ADDENDUM NO. 4

PROJECT NAME: City Campus Central Utility Plant – 2nd Floor Addition
UNL PROJECT NUMBER: C028P243
UNL INVITATION NUMBER: 2298-14-7200

DATE OF ISSUANCE: Wednesday, February 5, 2014

Addendum #4
Sheet A1.00

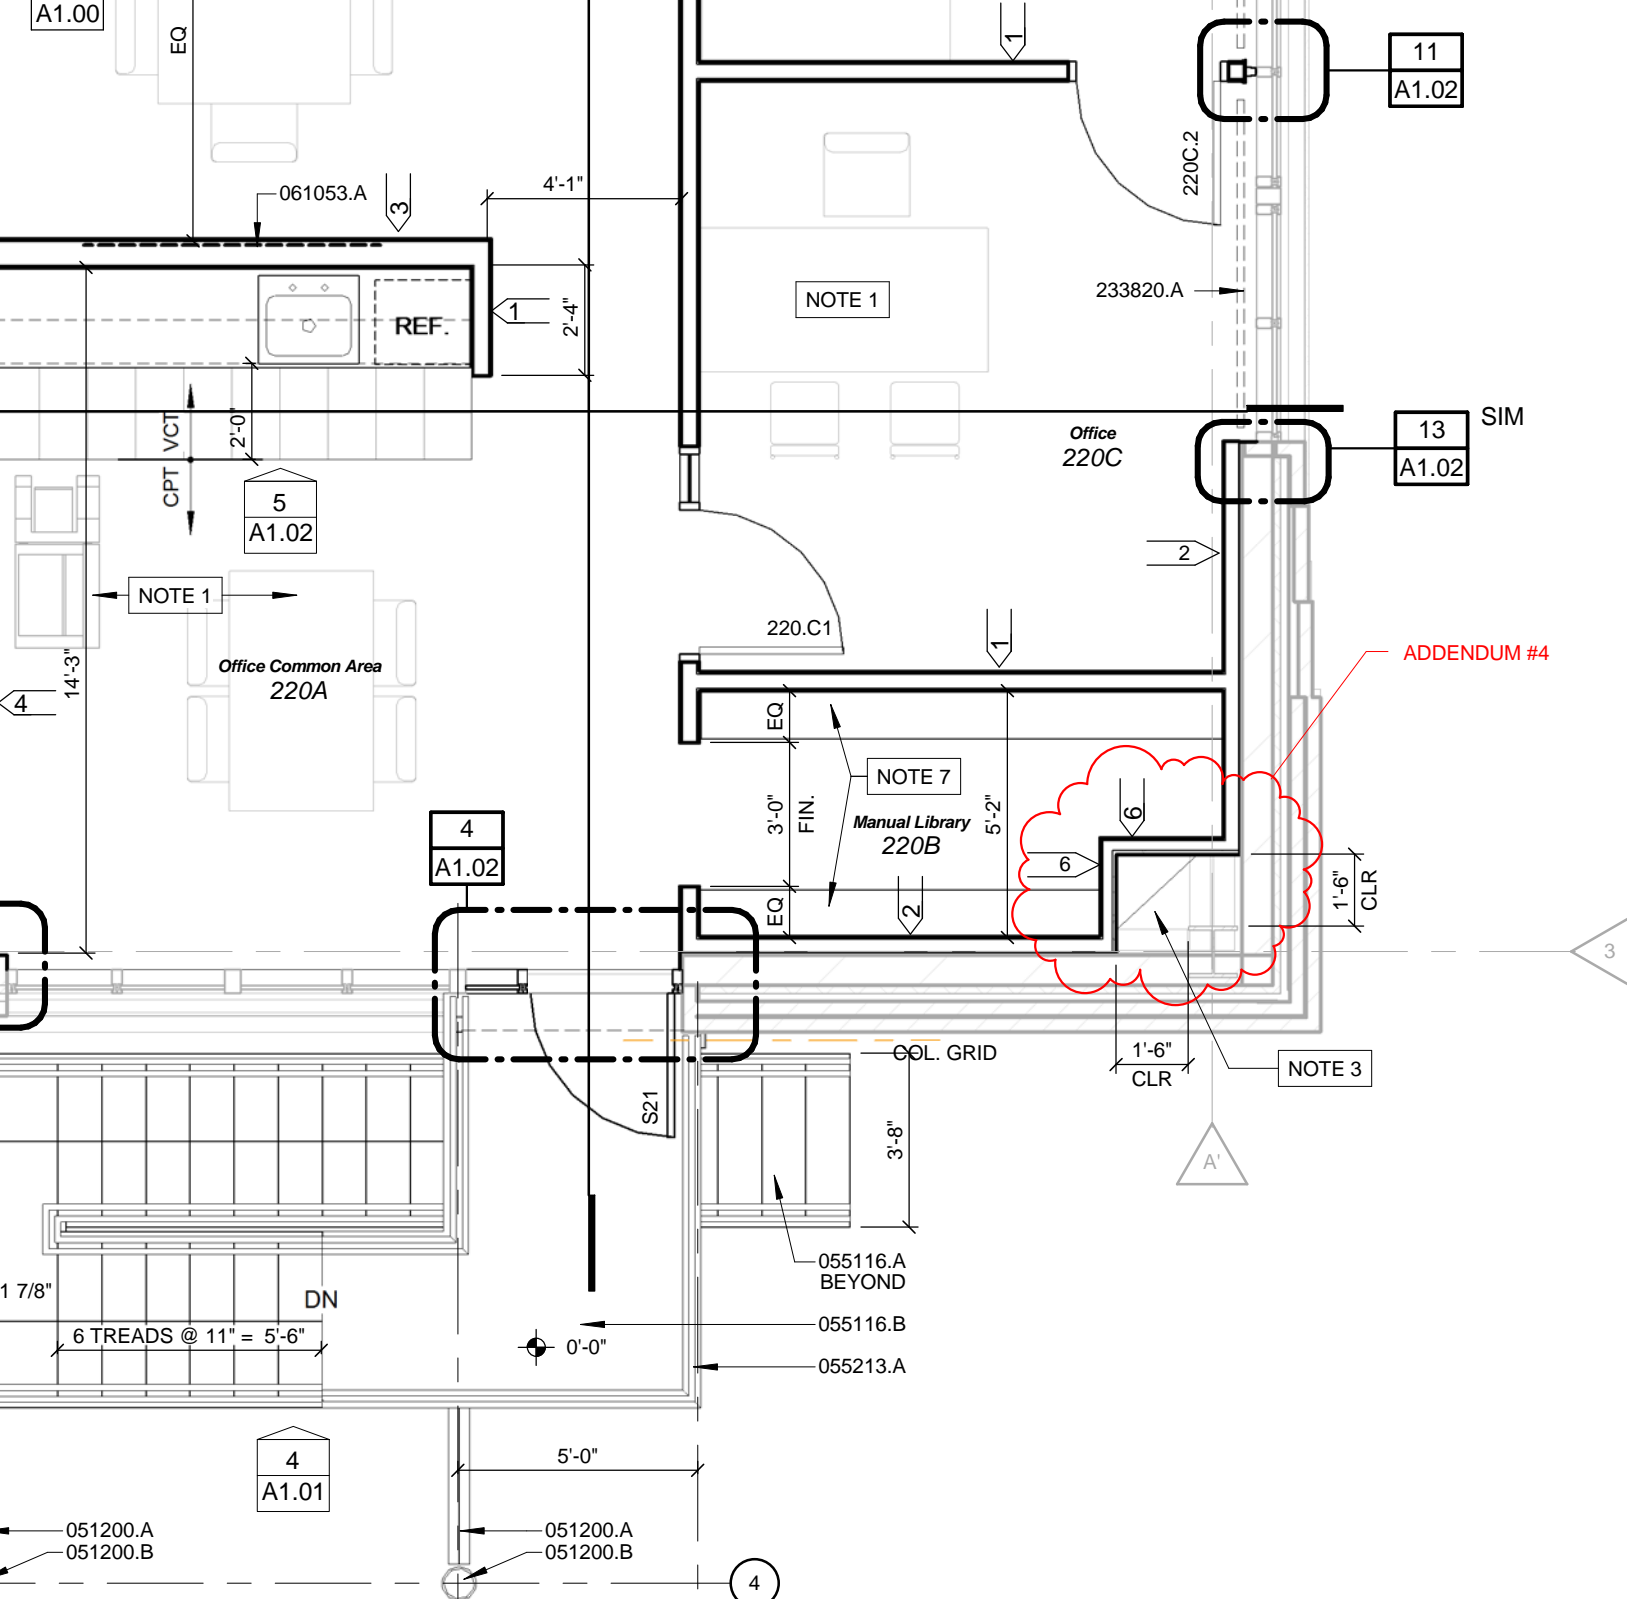
1. Refer to Operator Floor Plan: Remove reference to 078123.A INTUMESCENT FIREPROOFING at underside of Vestibule 299A.
2. Refer to attached Operator Floor Plan sketches. Add Wall Type 6 as indicated at mechanical chases located near column grid intersections A'-3 and A.01 – 1. See Specification Section 092116.23.
